Access Compliance Report

Public Rights-of-Way

(Curb Ramps)

Intersection ID: 31553	Main Street: CALDWELL_RD	Cross Street: CALDWELL_RIDGE_PY	Location: S
ADA ID: 116EBF4EA8C4	Ramp Type: BlendTrans1	Initial Pass/Fail: Fail	Overall Compliance: No
Severity Score: 8.75			
Codes/Mitigation Info/Possible Solution		Field Measurements/Component Compliance

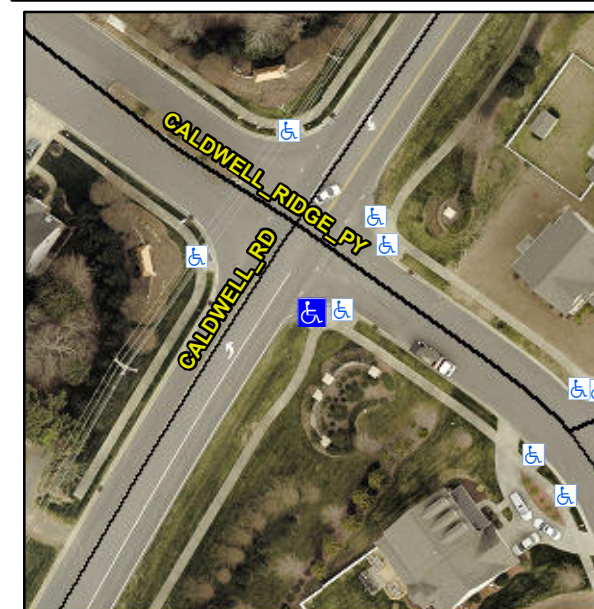
Not Found, R304.5.1

Compliance	Description	Data	Compliance	Description	Data
N/A	Ramp Length (in)	71.0	Yes	BlendTrans Slope (%)	4.3
No	Ramp Width (in)	47.0	Yes	BlendTrans XSlope (%)	1.5
N/A	Flare Type LT	N/A	N/A	Flare Type RT	N/A
N/A	Flare Slope LT (%)	N/A	N/A	Flare Slope RT (%)	N/A
N/A	Flare Traversable LT?	N/A	N/A	Flare Traversable RT?	N/A
N/A	Landing Length (in)	N/A	N/A	DWS Provided?	N/A
N/A	Landing Width (in)	N/A	N/A	DWS Contrast?	N/A
N/A	Landing Slope (%)	N/A	N/A	DWS Length (in)	N/A
N/A	Landing X Slope (%)	N/A	N/A	DWS Full Width?	N/A
N/A	Landing Curb? (Y/N)	N/A	N/A	DWS Offset (in)	N/A
N/A	Shared Landing?	N/A			
N/A	Gutter Ponding?	N/A	N/A	Gutter Slope (%)	N/A
N/A	Gutter Lip Ht (in)	N/A	N/A	Gutter X Slope (%)	N/A
N/A	Painted X Walk1?	No	N/A	Painted X Walk2?	N/A
	X Walk 1 Direction	To NW		X Walk 2 Direction	N/A
	X Walk 1 Width (in)	N/A		X Walk 2 Width (in)	N/A
	X Walk 1 Slope (%)	2.8		X Walk 2 Slope (%)	N/A
	X Walk 1 X Slope (%)	1.0		X Walk 2 X Slope (%)	N/A

N/A	Ramp inside XWalk1?	N/A	N/A	Ramp inside XWalk2?	N/A
	Road Slope (%)	1.0		Clear Space?	N/A
	Road X Slope (%)	2.8	N/A	Clear Space to XWalk (in)	N/A
N/A	Any Obstructions?	N/A	N/A	Storm Grate/Utility Hazard?	N/A
	Obstruction Type			Storm Grate/Utility Type	
		N/A			N/A
			Yes	Surface Condition? (G/P)	Good
			No	Curb Slope (%)	11.6

Remove & Replace Curb Ramp With Two New Directional Ramps or Equivalent.
